MEMORANDUM

DATE: September 19, 2007

SUBJECT: Revised interpretation of the structural contact between the Quaternary alluvium and the Tertiary Muddy Creek formation in borelog BRC-SB-27-A located near the southern border of the BRC eastside property in Henderson, Nevada.

Boring Log: BRC-SB-27-A-R (Revised 09/07/07)

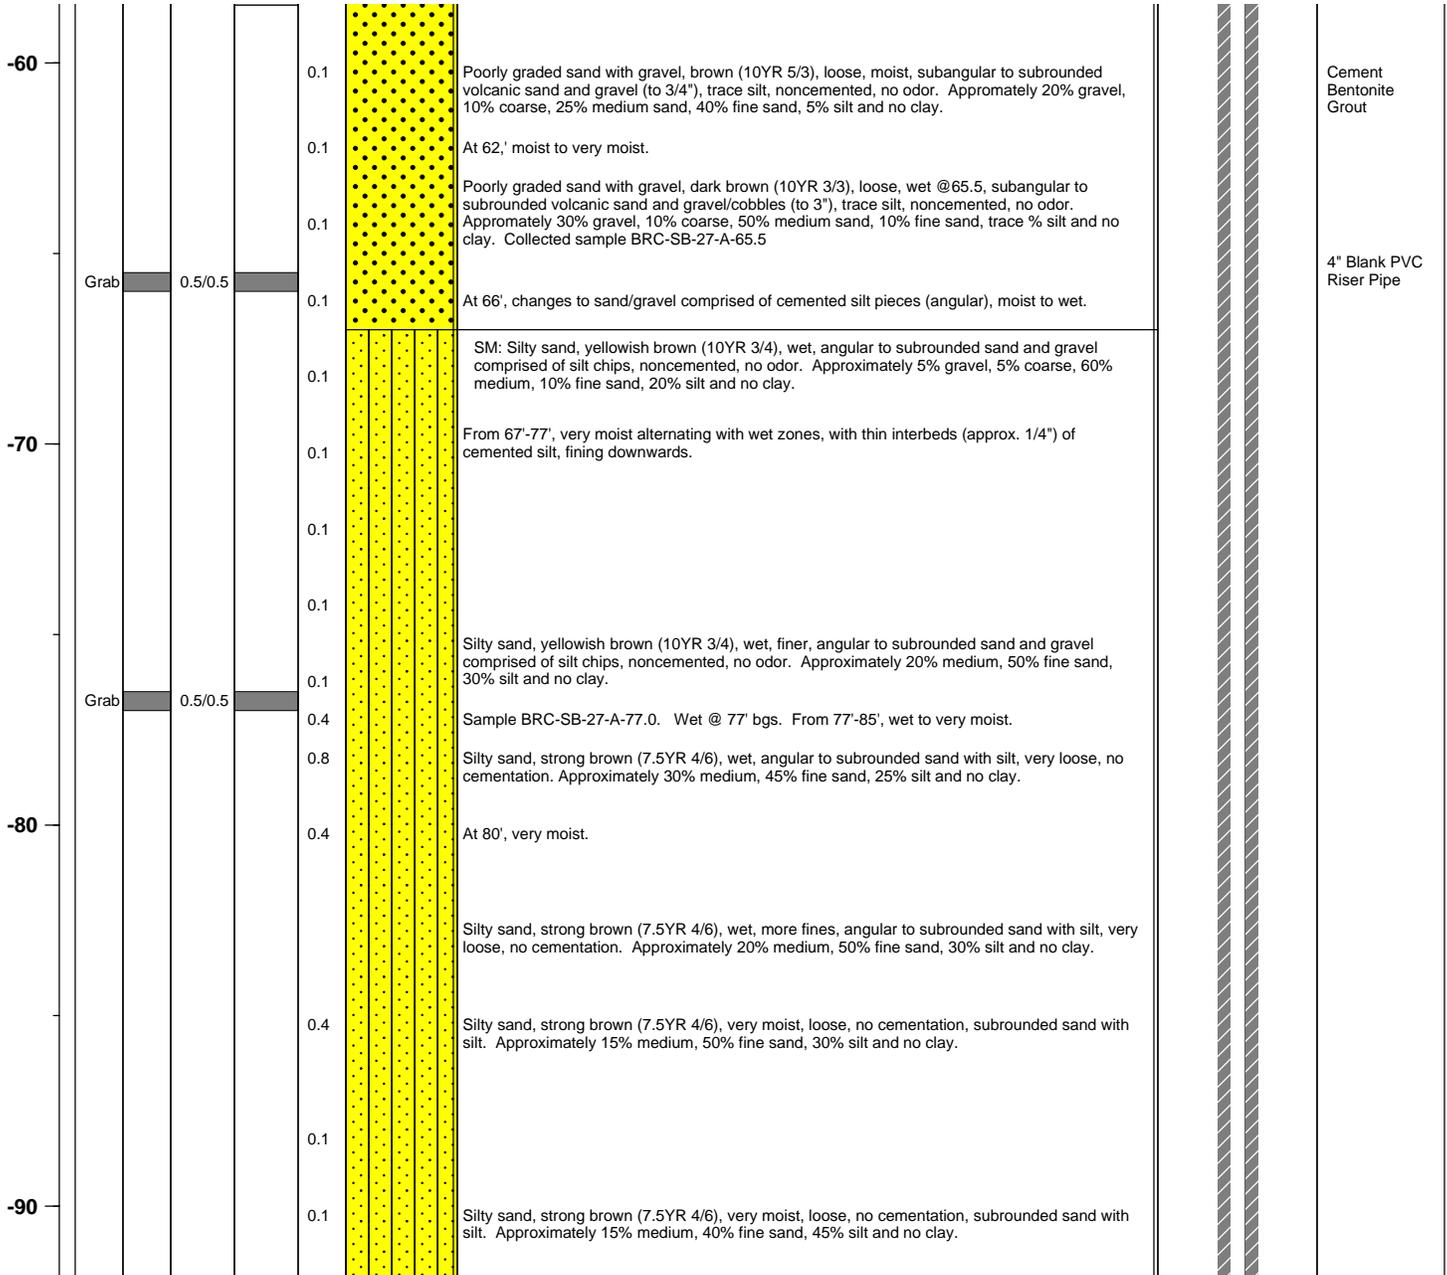
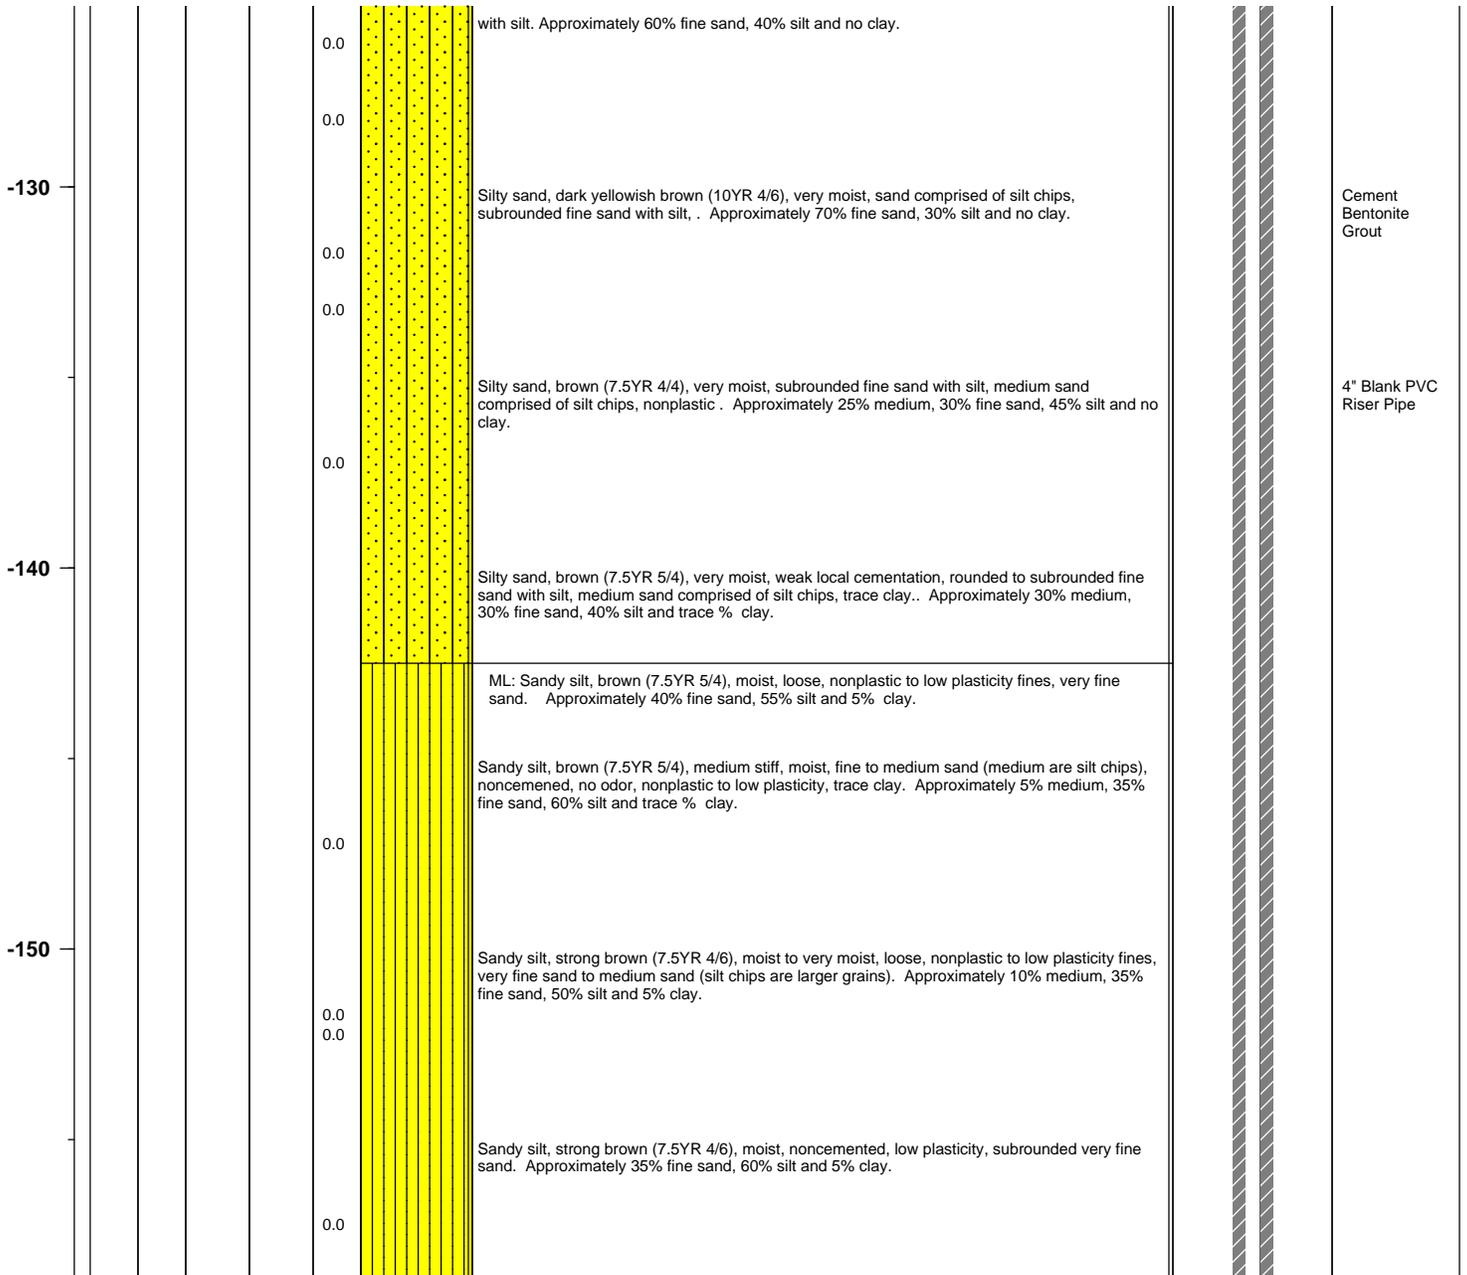
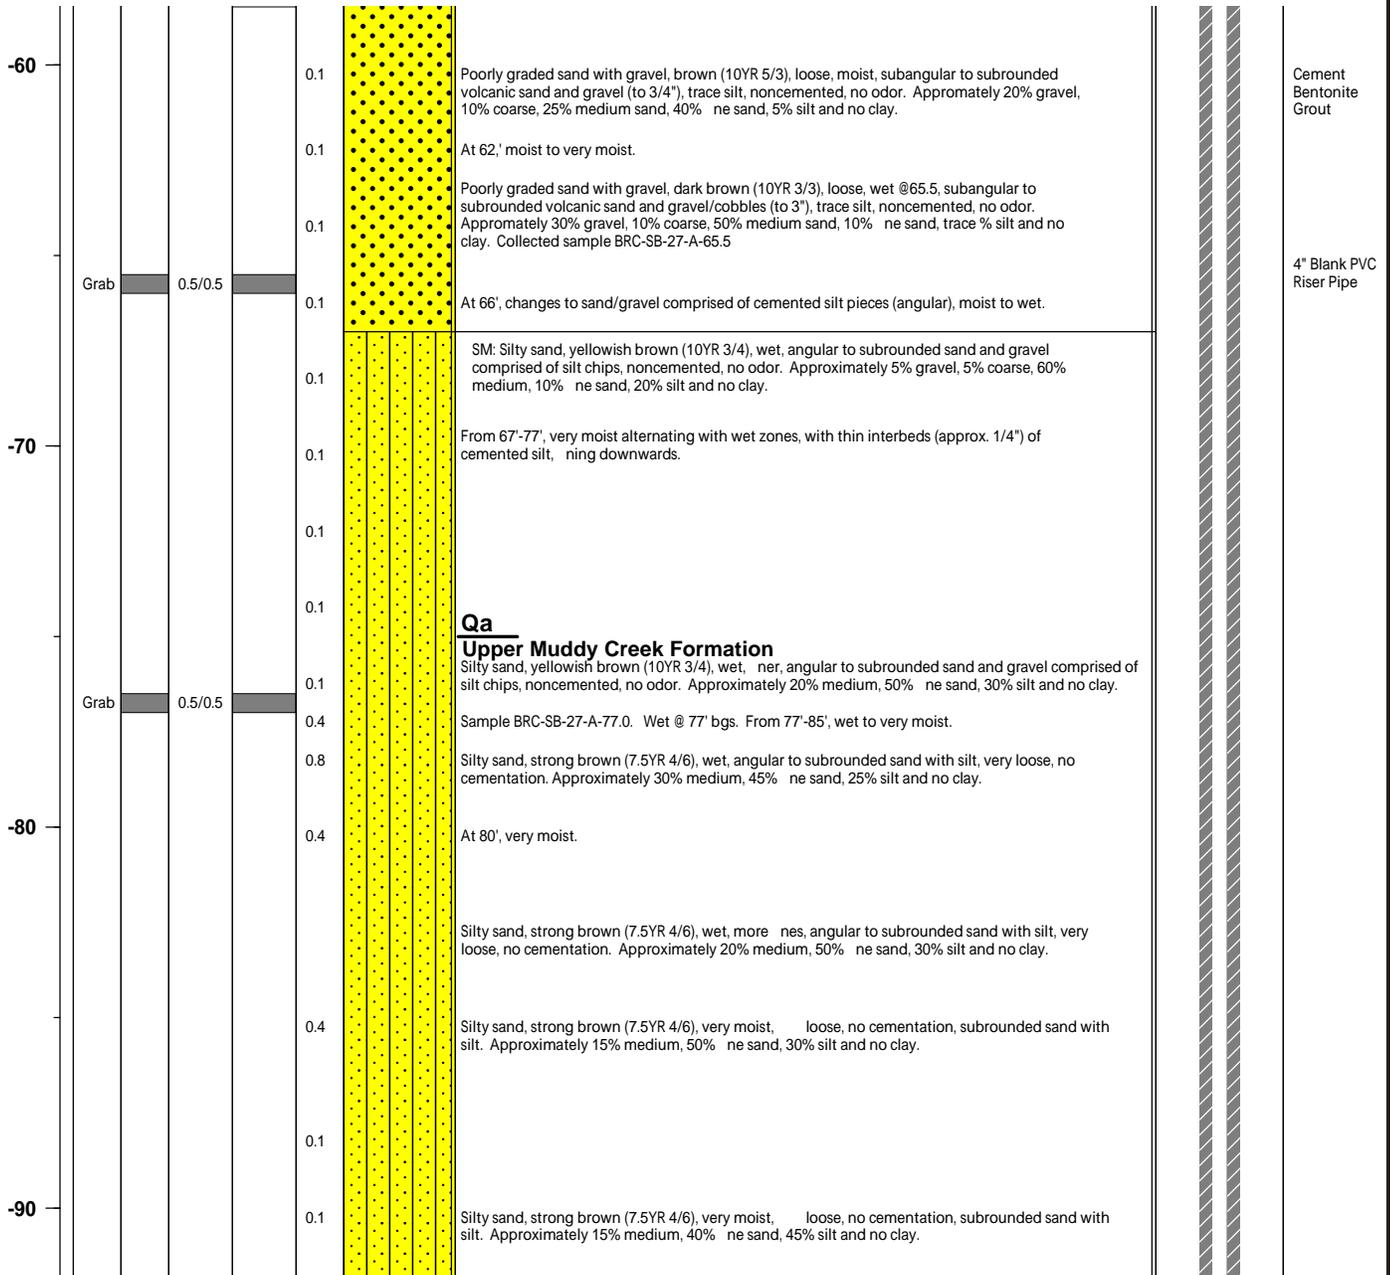
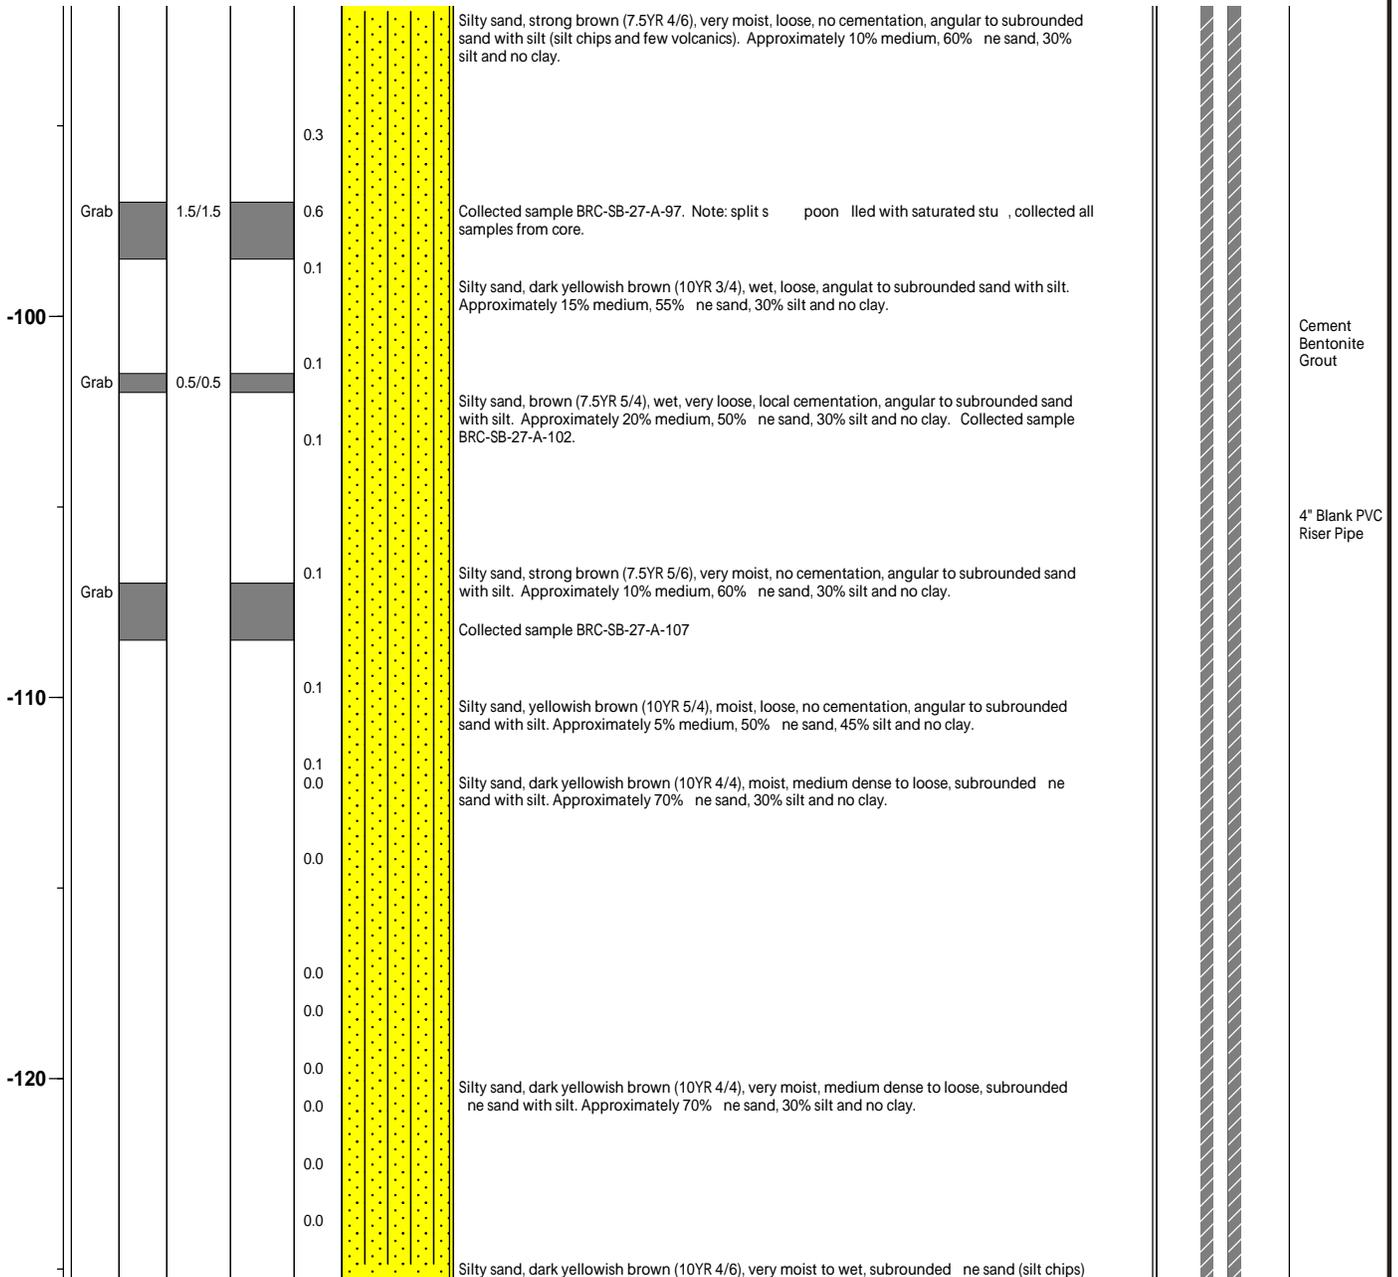
Subsequent to the original interpretation of the Qal/TMC contact for BRC-SB-27-A, creation of a Qal/TMC structural contour map made it clear that the data point at Location 27 was much deeper than data points surrounding Location 27. This apparent anomaly resulted in an unexplained “hole” in the Qal/TMC structural contact surface. After study of the borelog details and the details of borelogs from the surrounding vicinity, the interpreted Qal/TMC contact was revised to a depth of 75 ft bgs. A discussion of the rationale for this re-interpreted contact follows.

In the original borelog, silty sand (SM) contacts sandy silt (ML) at 143 ft bgs. The basis for this interpretation is apparently a perceived change in soil texture. However, there is no clearly distinct contrast here with approximately equivalent percentages of sand, fine sand, and silt on both sides of the contact. Color is also the same on both sides of the contact. While not attempting to second guess the field interpretation, the difference between SM and ML can be a difficult distinction to make in the field. It is possible that a laboratory sieve analysis would determine that the soil texture below the 68 ft bgs level is ML instead SM. If reconsidered as ML, then ML would be logged beginning at a depth of 68 ft bgs instead of 143 ft bgs.

A more notably distinctive change in the geologic materials occurs in the depth range of 70 to 75 ft bgs. Above this depth range, the original log describes the soil as brown in color with subangular to subrounded cobbles-gravels sized to 3” in a dominantly volcanic sand matrix. At the bottom of this depth range, the color changes to yellow-brown with no mention of cobbles, and there is no mention of a volcanic sand matrix. The soil texture is described as silty sand with angular to subrounded sand and gravel comprised of silt chips. Bell and Smith (Geologic Map of the Henderson Quadrangle, Nevada, 1980) state that the Qal is composed of volcanic/dacitic sand and gravel. Other borelogs from the vicinity (Locations 1 and 2) describe volcanic/volcaniclastic sand/gravel above the contact (in those cases, above the soil described as ML). At Location 27, volcanic/volcaniclastic sand/gravel occurs in the soil described as SP (above 68 ft bgs) but not in the underlying SM (below 68 ft bgs). Bell and Smith (1980) also describe the coarse-grained facies of the TMC as, “consisting of yellowish- to reddish brown fanglomerate... (this) upper portion consists of volcanic pebbles”. In the original borelog, a transition zone below the Qal of brown mixed Qal and TMC (68 to 75 ft bgs) fining downwards to the yellowish-brown TMC is consistent with this description by Bell and Smith.

The depth interval between 68 ft bgs and 75 ft bgs is described in the original borelog as a transition zone with silty sand alternating with thin interbeds of cemented silt. At a depth of 75 ft bgs, the log describes an increase in silt content which is sustained in the soil descriptions for the underlying depths.

As DBS&A and BRC discussed with NDEP, the contact could have also been selected at 68 ft bgs. As noted by NDEP, the material logged from 68-75 ft bgs appears to be more similar to the materials below this depth than the materials above this depth, which suggests the contact is at 68 ft bgs.

However, as NDEP also noted, if the materials from 68-75 ft bgs are actually re-worked sediments, then identifying the contact at 75 ft bgs is more appropriate. There is no field evidence, however, that can be used to determine if primary sedimentary structures are preserved or disaggregated in the logged materials, so a distinction of re-worked materials can not be made.

DBS&A has elected to identify the Qal/TMC contact at 75 ft bgs based on the significant increase in percent fine sand and silt content recorded at 75 ft bgs (nearly double or more than that in the overlying depth intervals). From a hydraulic standpoint, the moisture content log is also consistent (albeit not proof) with an interpretation that water observed above the interbeds is in communication with water in and below the interbeds.

Based on the foregoing rationale and discussion, the depth to the Qal/TMC contact at Location 27 is revised to occur at a depth of 75 ft bgs. A revised borelog (BRC-SB-27-A-R) is attached in Attachment B to document this revision.
